Product Announcement

New Drum Brake For High Cycle Trolleys MOD 113

Manaras/Opera New Drum Brake MOD 113

Drum
Brake ▶▶▶

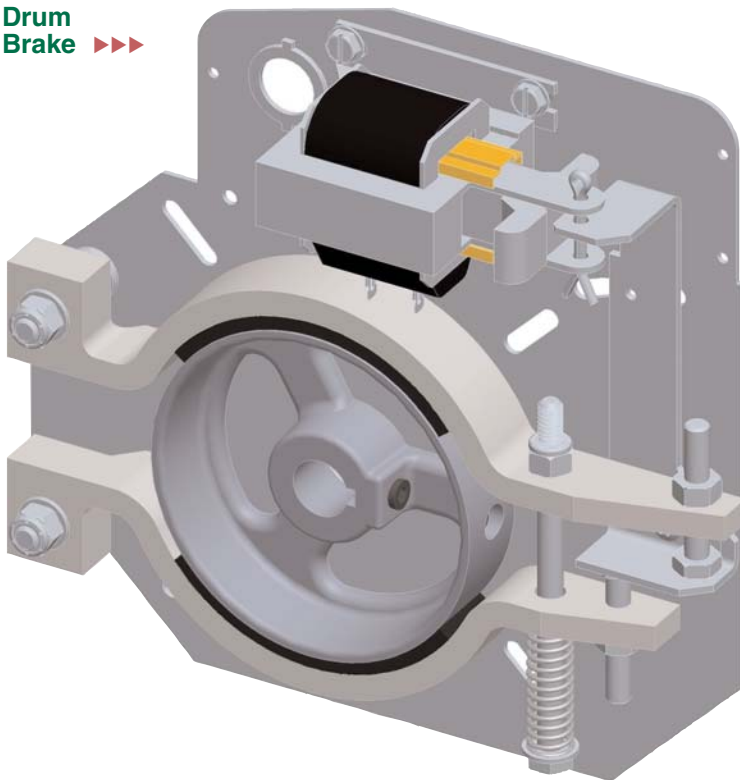
Responding to your needs, Manaras/Opera will be offering an optional Drum Brake for High Cycle Trolley applications beginning February 1st 2007.

The drum brake modification (MOD 113) is an available option for models: MTBH, APT and APE.

- Increased lifetime in comparison to existing band brake for high cycle applications.
- The amount of time before the first brake adjustment is increased.
- The tension placed on the solenoid is reduced, therefore increasing its lifetime.
- The brake has a smoother operation.
- The drum brake is also available as an assembly kit (BRAKE 014) for existing operator upgrades.

Please note that the models listed above will continue to be manufactured with the standard band brake unless MOD 113 is specified on the order.
